10. *The Park Advisory Board recommends that the Planning Commission and the Board of County Commissioners include the following conditions when considering and/or approving the Paint Brush Hills Filing No. 14 Final Plat: (1) Provide to El Paso County a 25-foot trail easement along the northern boundary of Paint Brush Hills Filing No. 14 Final Plat, within Tract A, that allows for the construction, maintenance, and public access of the Arroya Lane Primary Regional Trail, and dedicate the aforementioned easement to El Paso County prior to the recording of the Final Plat; (2) The developer will relocate the proposed storm facility from Tact A to allow the trail to be constructed on the trail easement or provide the trail easement through lots 24-30.*

STREET IMPROVEMENT PLANS

PAINT BRUSH HILLS FILING NO. 14

UT05

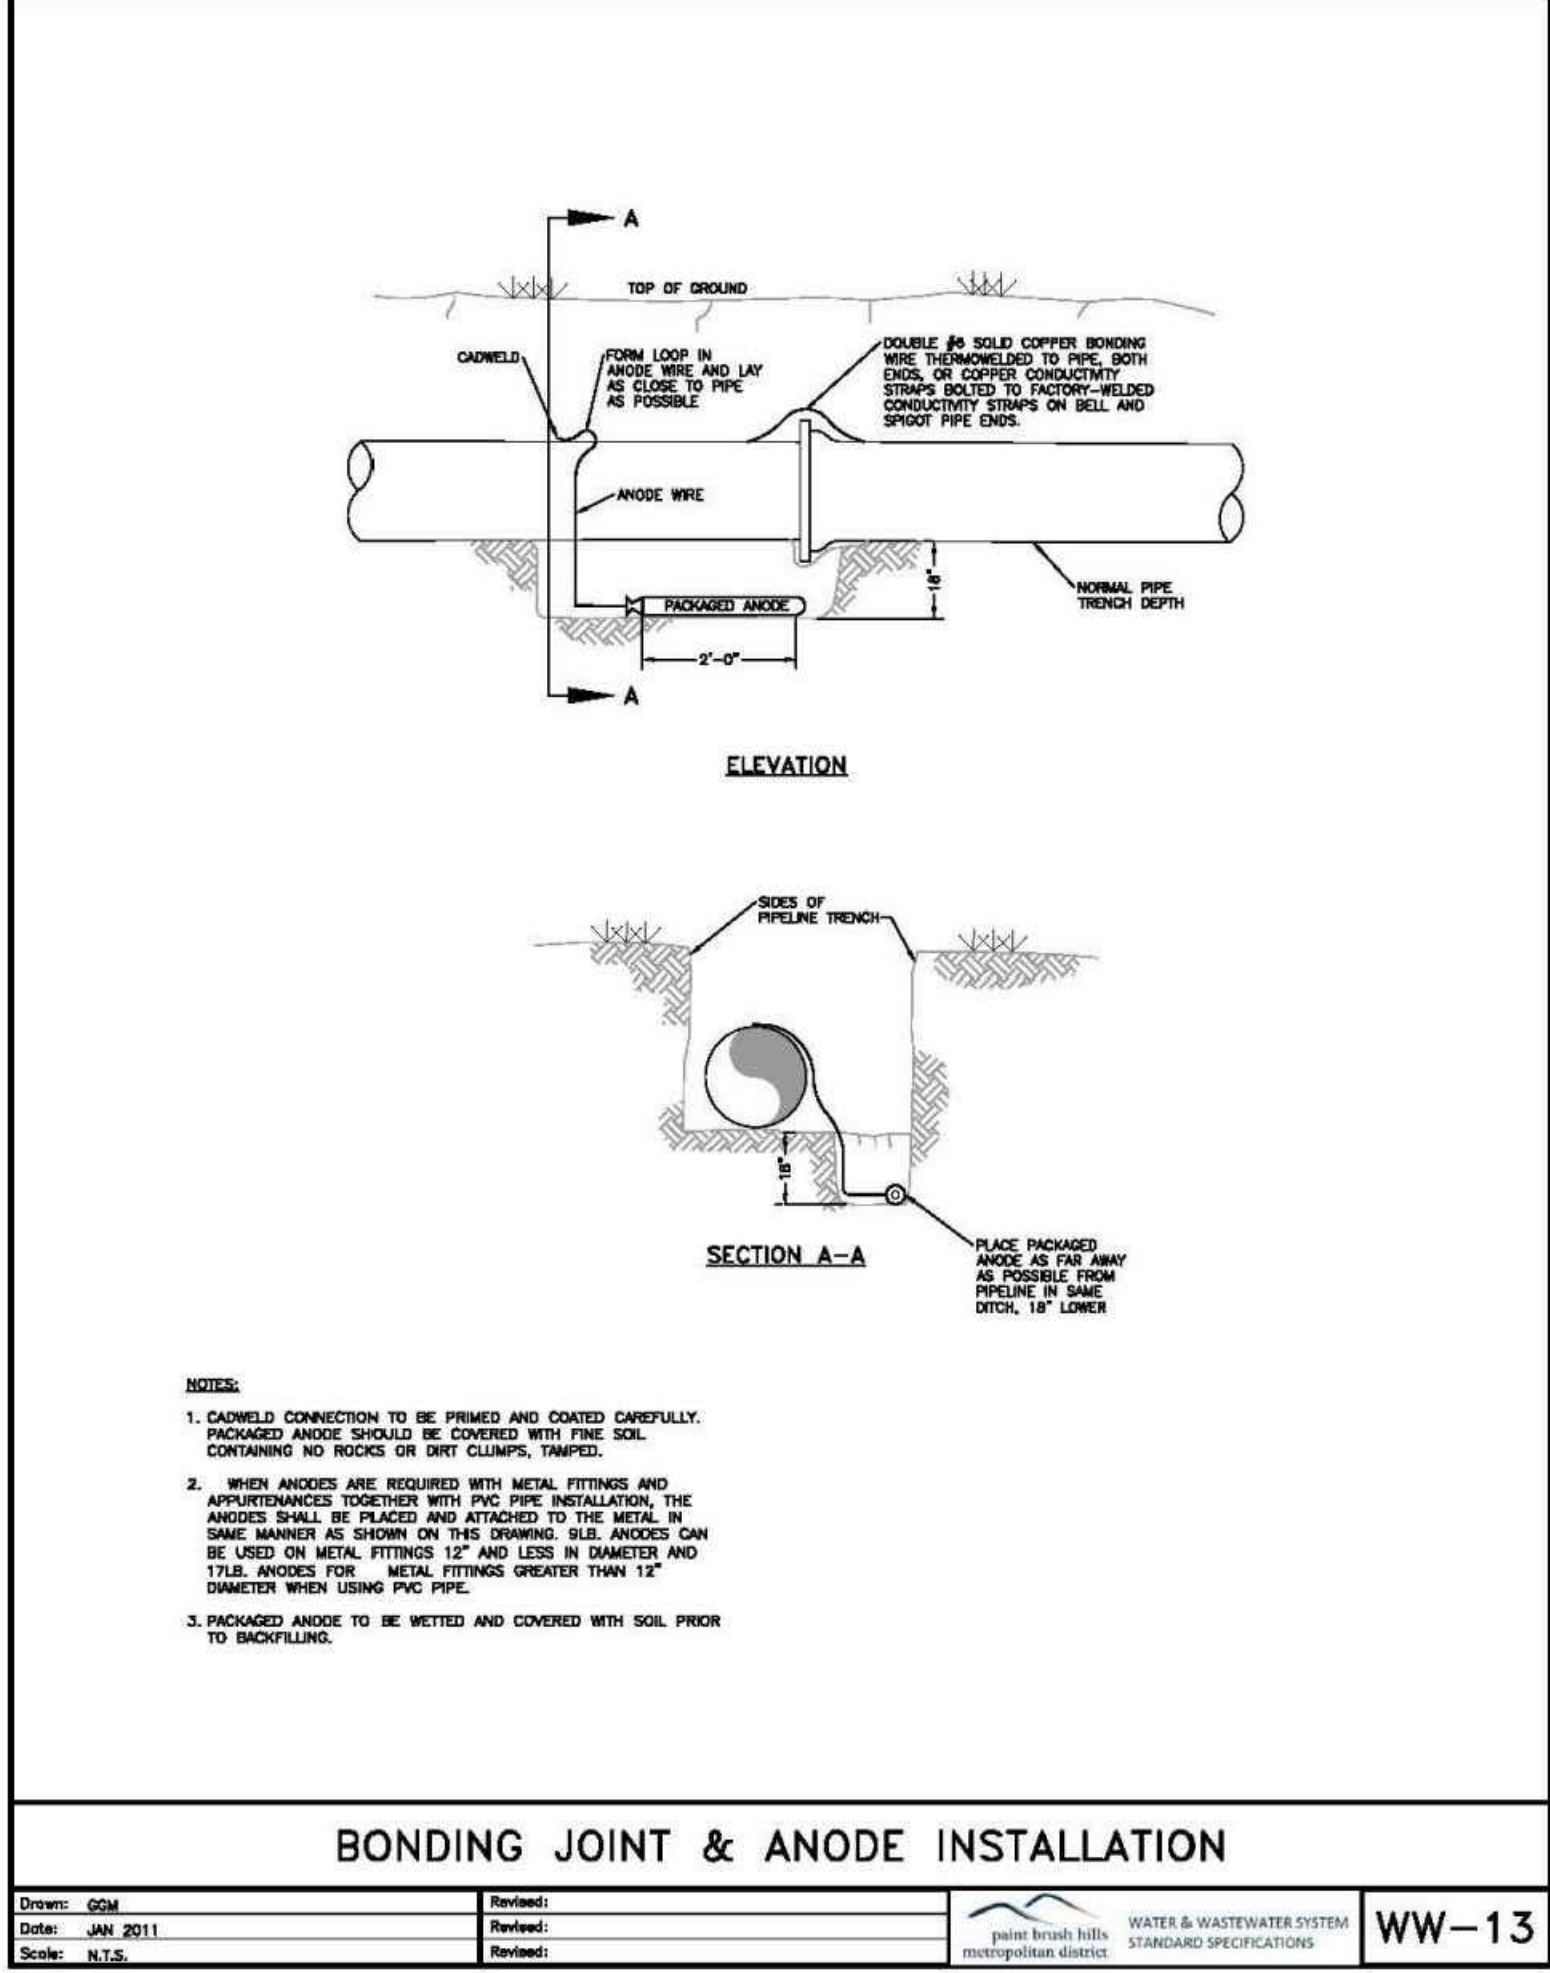
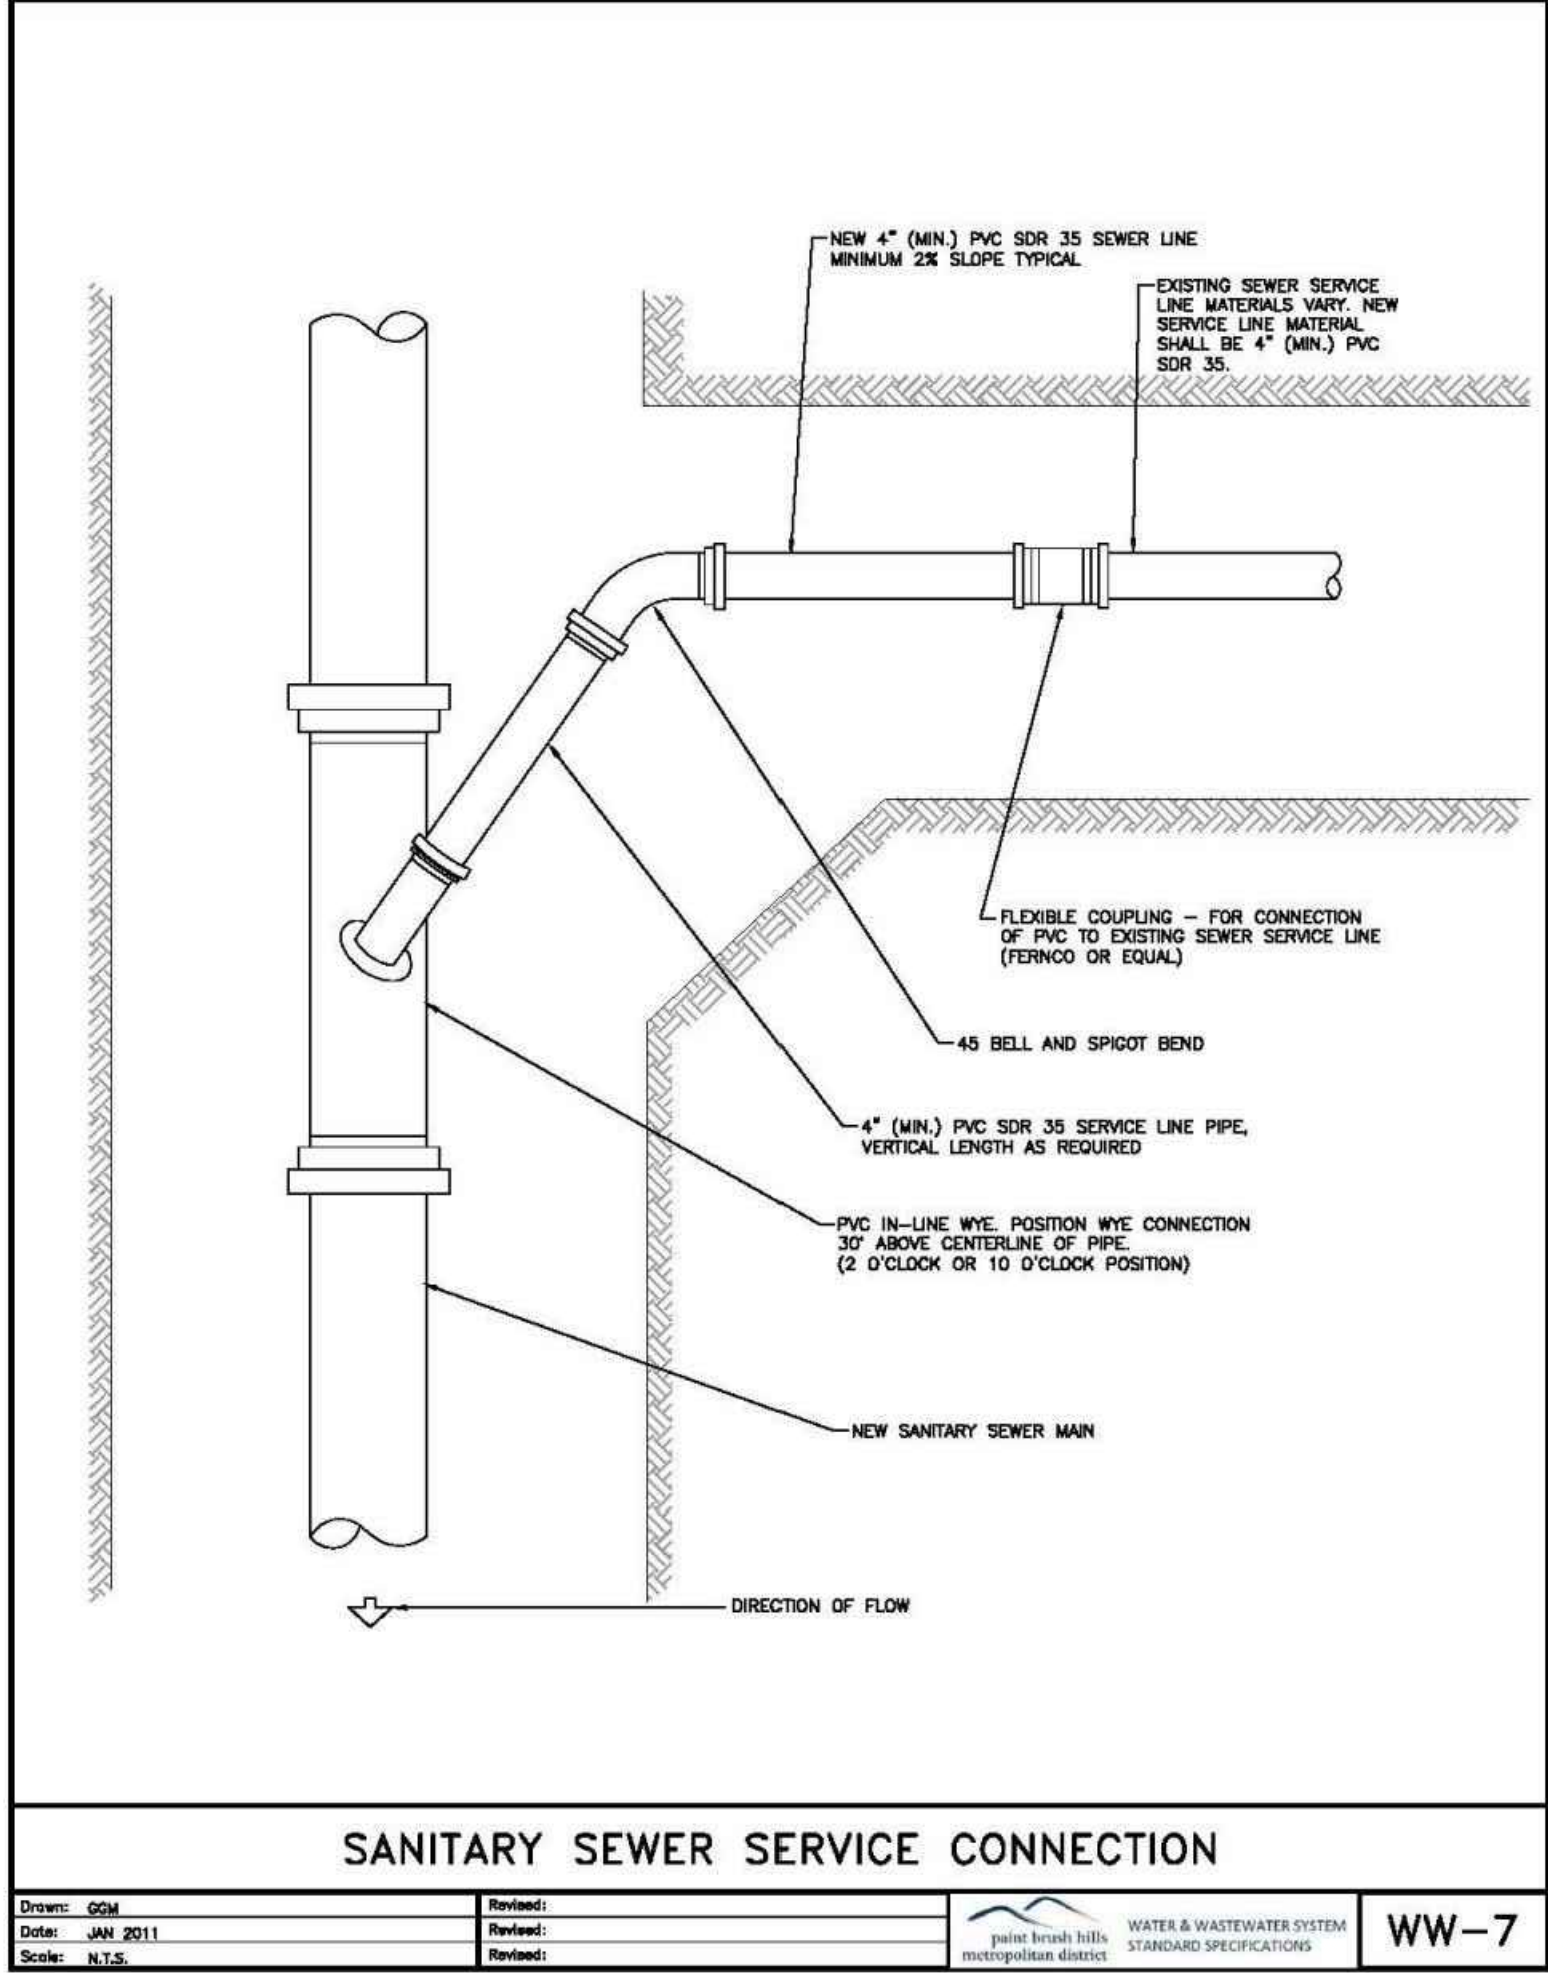
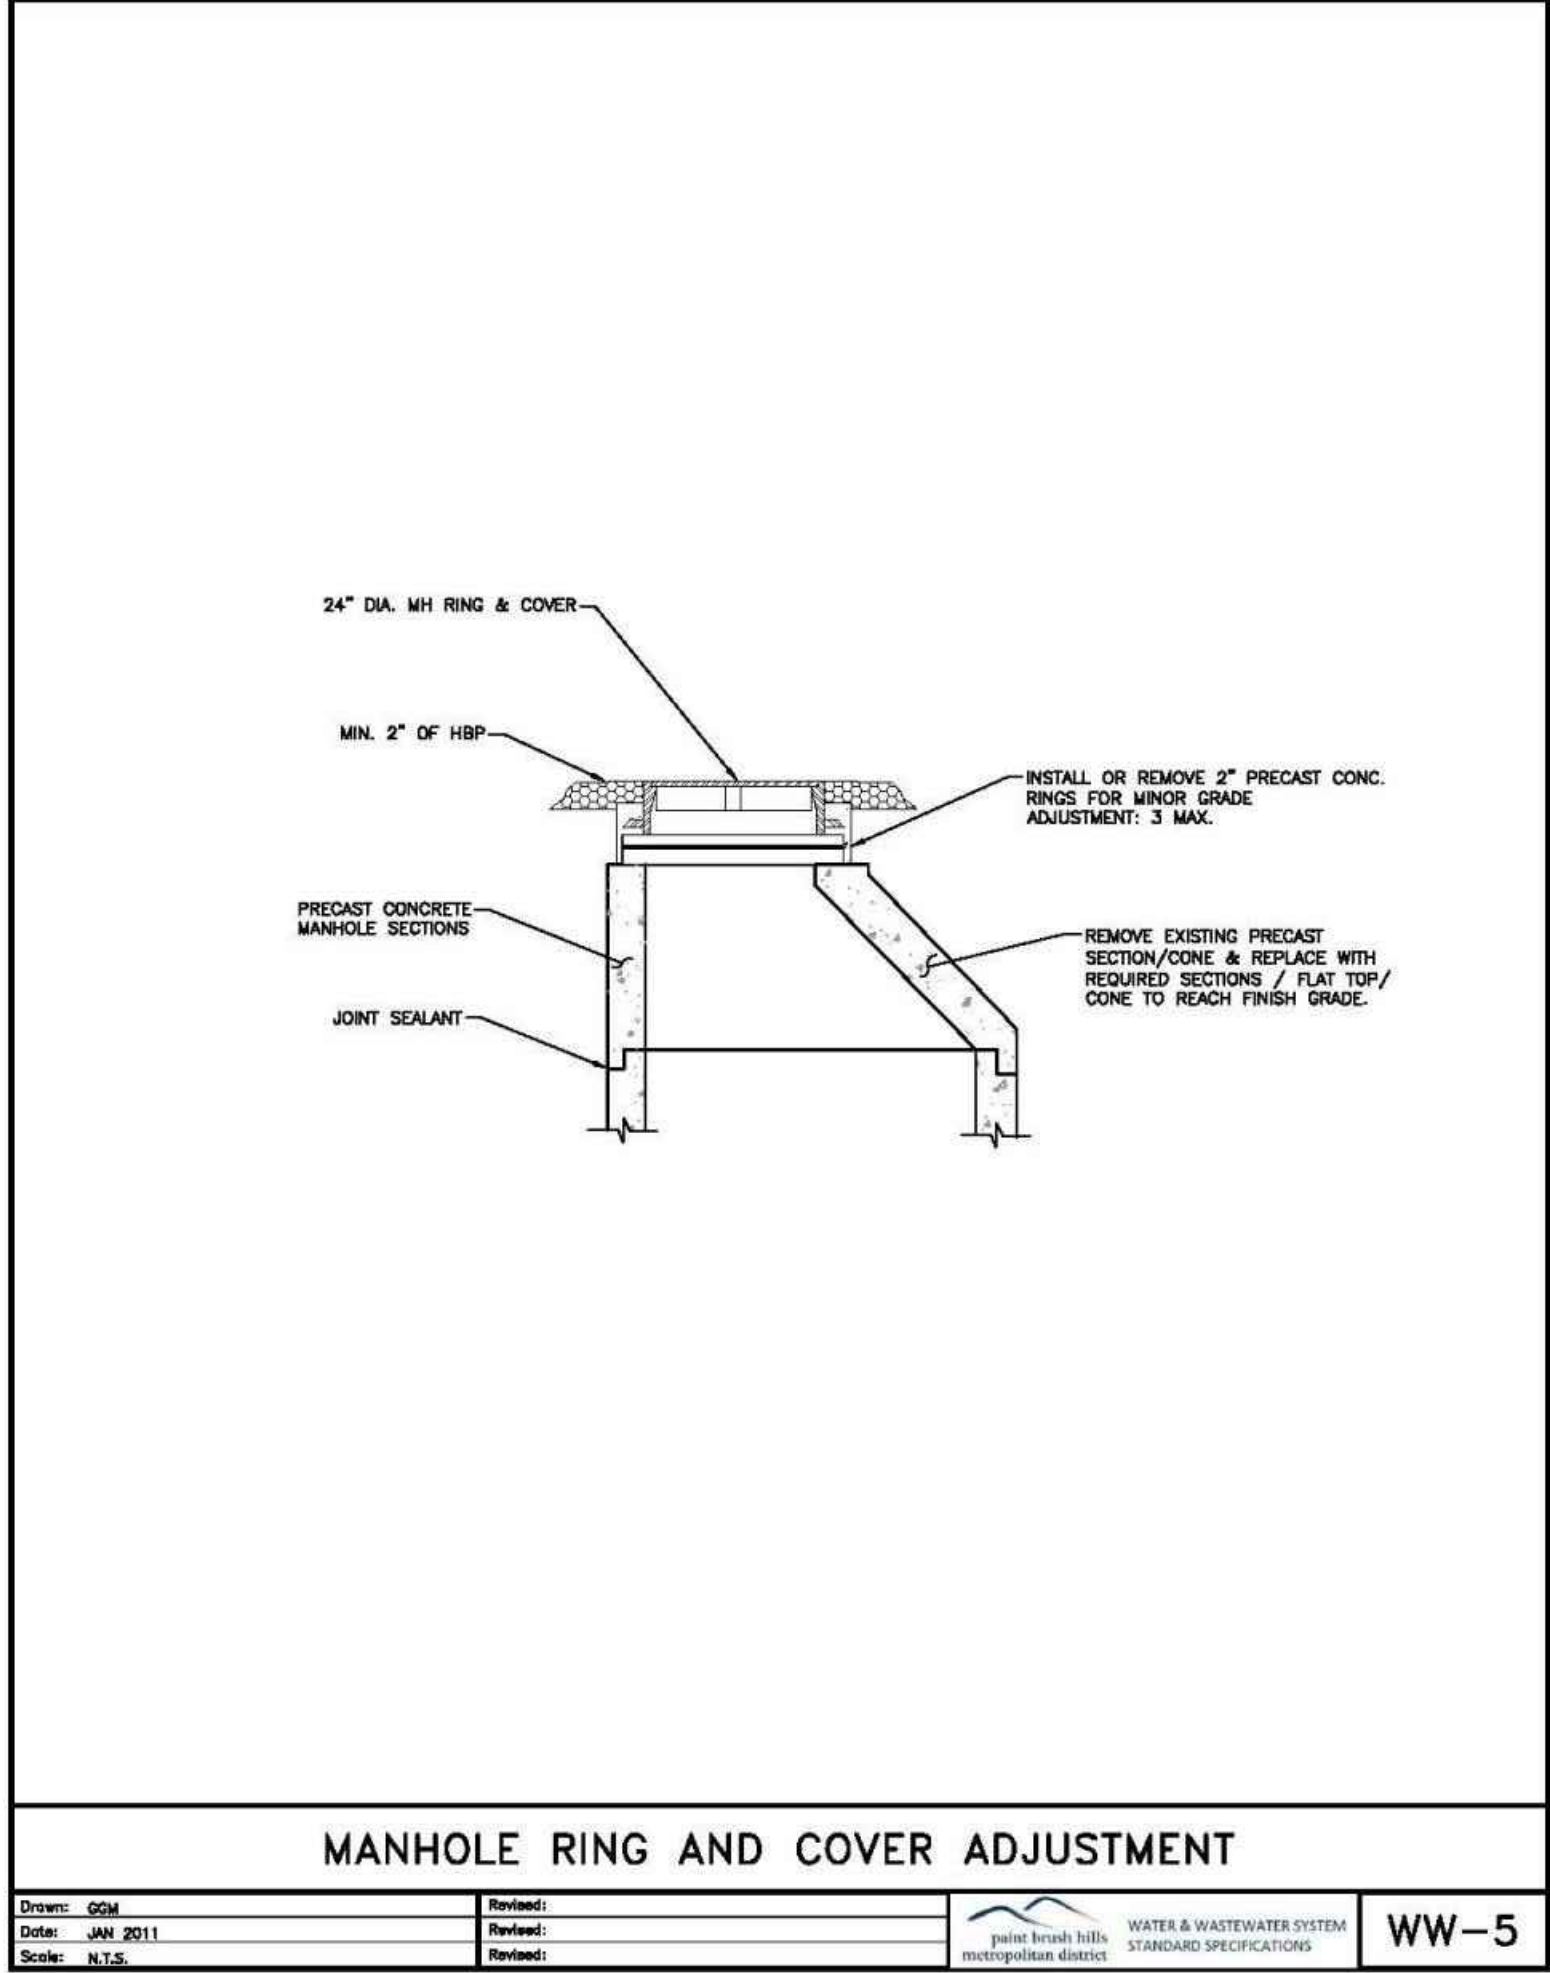
provide underdrain details

Added as requested
